Halton Hills #4 WWPS Municipal Class Environmental Assessment

Indigenous Communities, Agency, and Public Comments Log

02 NECESSITY

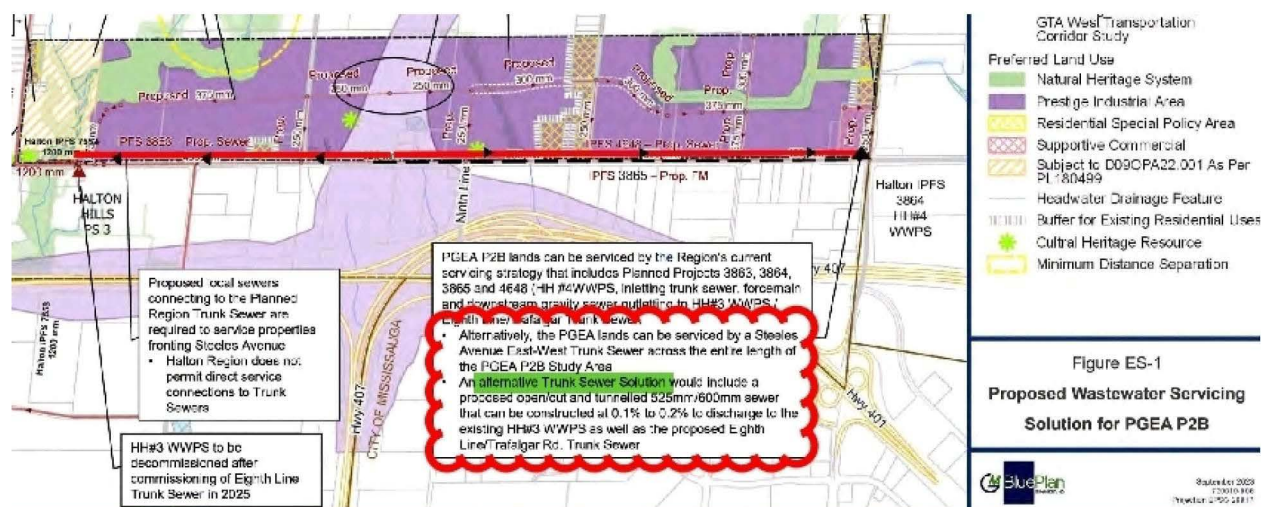
The Premier Gateway Employment Area from approximately 1km east of Ninth Line North would be serviced by proposed HH#4 Wastewater Pumping Station, the scheme includes:

- New lot creation/property acquisition;
- New access to Steeles Avenue (RR 8);
- Site servicing, including power, gas, and communications;
- Sewage wet well, equipment gallery, mechanical, electrical, piping, instrumentation, superstructure;
- Standby power, driveway and parking, and landscaping;
- 2.5 km trunk sewer 450mm;
- 5 km forcemains (dual); and
- 1.5 km downstream trunk sewer (600mm) outletting to the 1,200mm Eighth Line/Trafalgar Trunk Sewer in proximity to the former Halton Hills #3 WWPS site.

This type of facility-based infrastructure, in addition to significant capital costs, will require significant energy inputs, and resultant GHGeq emissions). Additional ongoing costs will be incurred to monitor and maintain the complex mechanical and electrical components, and upkeep of the site and facilities.

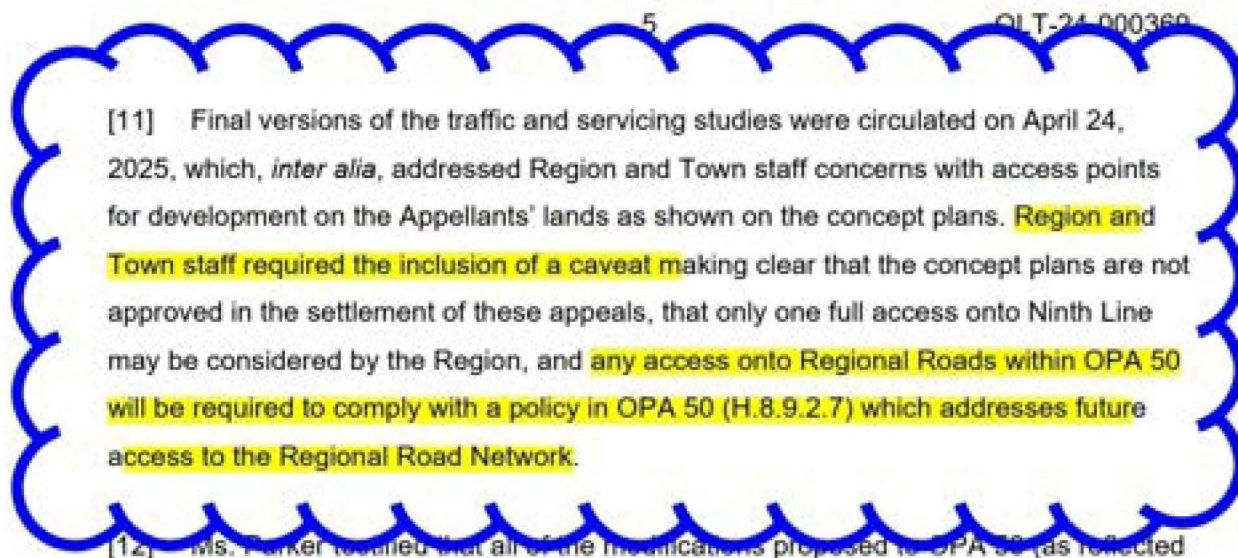
- 3.6. There is no provable necessity to focus on creation of a new lot adjacent to our property when they could easily set their view on an existing parcel on the South side of Steeles or along Tenth Line with existing access as planned since 2002. We have not been provided any technical or financial justification that would support this change.

- 3.7. No soil sampling is being conducted for alternative locations confirming the preselection of the preferred location.
- 3.8. The site plan proposed by the Region (Dwg. C900, January 2013) did not conform to the Town's policy (401 Corridor Integrated Planning Project: Design Guidelines. Town of Halton Hills, 2000) and does not conform to Premier Gateway Employment Area Phase 2B Secondary Plan. OPA 50.
